Bruner, Cooper & Zuck, Inc.

ADDENDUM NO. 2
TO THE
PLANS AND SPECIFICATIONS FOR
SANITARY SEWER SYSTEM
BRENTWOOD AND PARKVIEW SUBDIVISIONS
KNOX COUNTY, ILLINOIS

PLAN & PROFILE LATERAL B-1 STA. 0+00 - 15+00
 BRENTWOOD SUBDIVISION - OAK RUN DEVELOPMENT
 SPOON VALLEY LAKE SANITARY DISTRICT
 KNOX COUNTY, ILLINOIS

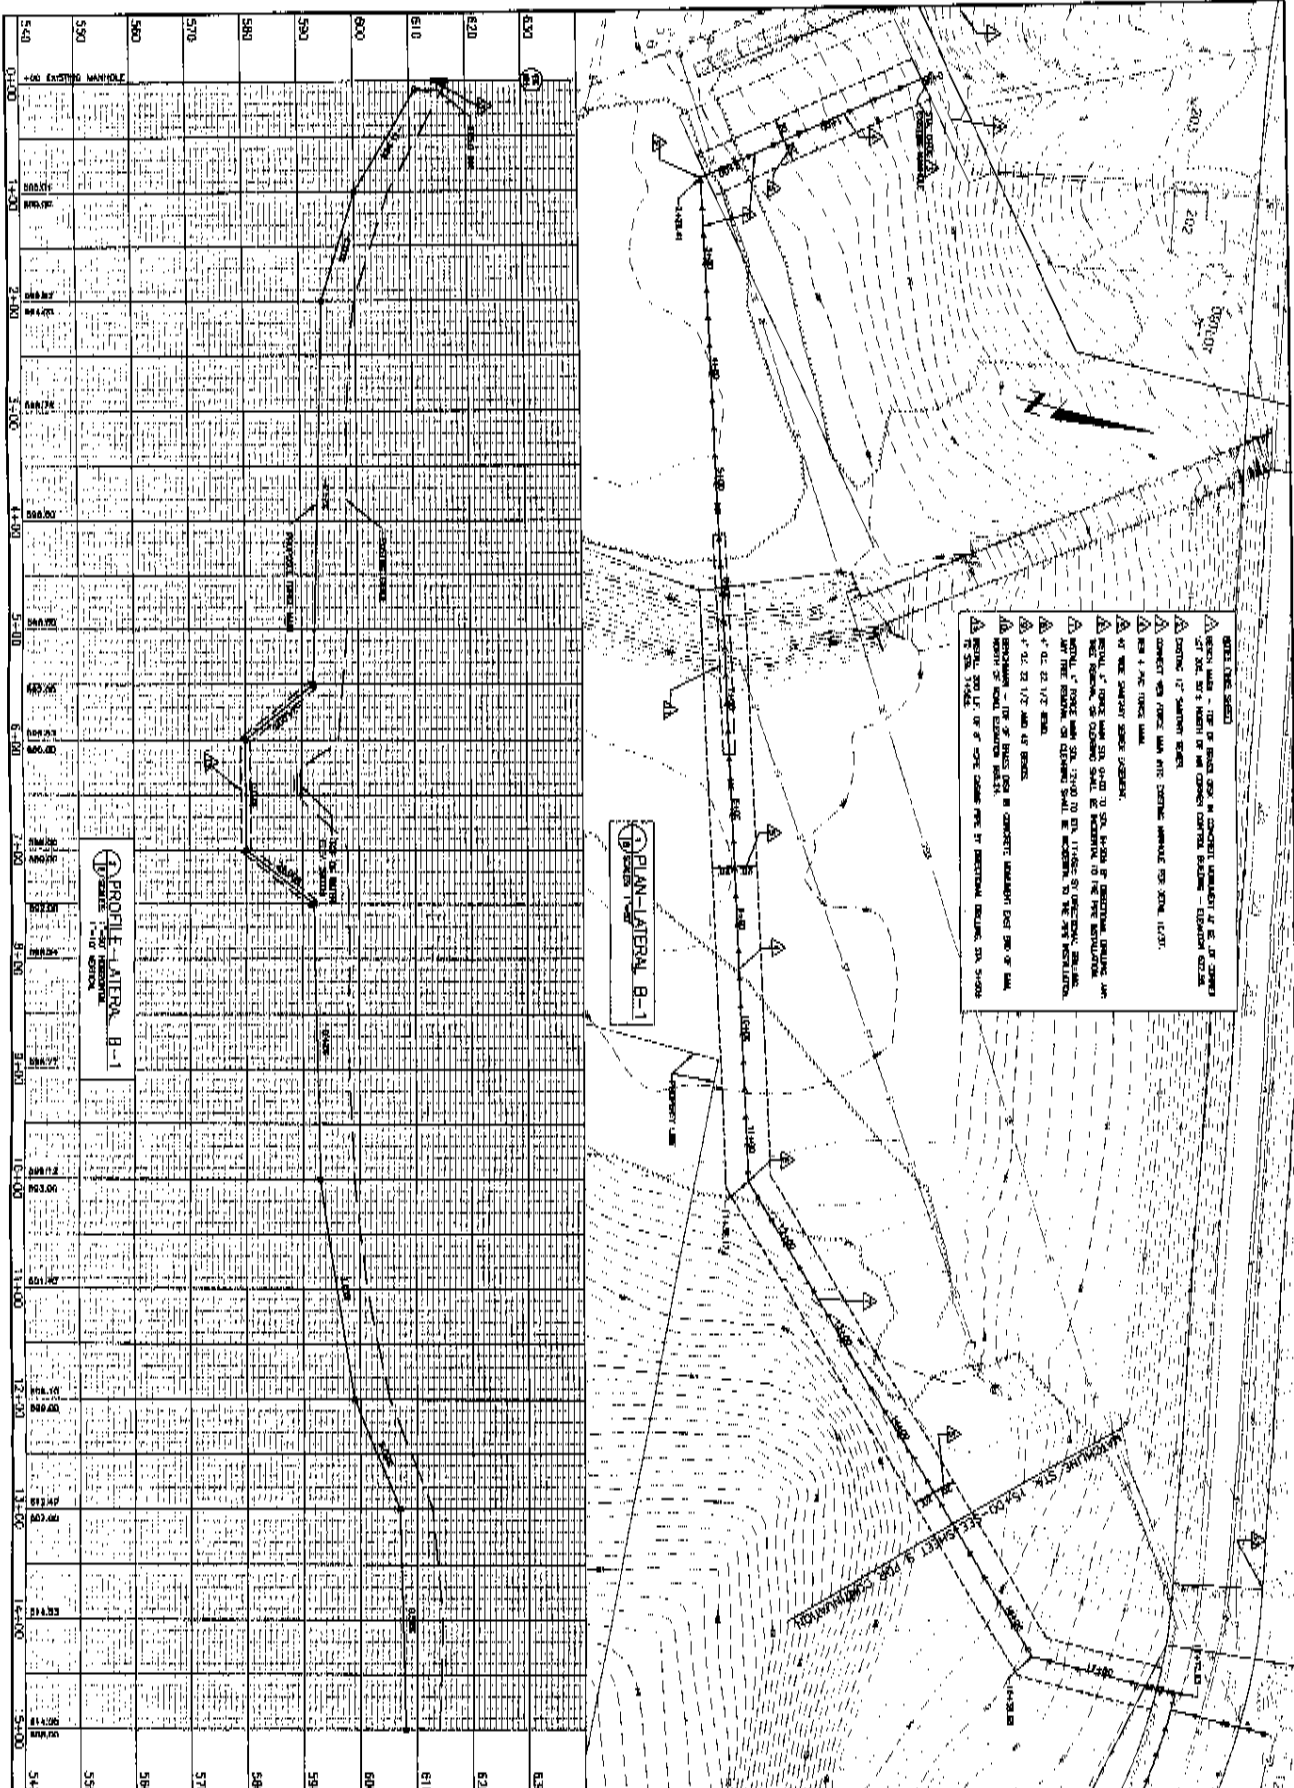
1. Replace Sheet 8 of 38 with the attached revised Sheet 8 of 38, which has added Note No. 11.
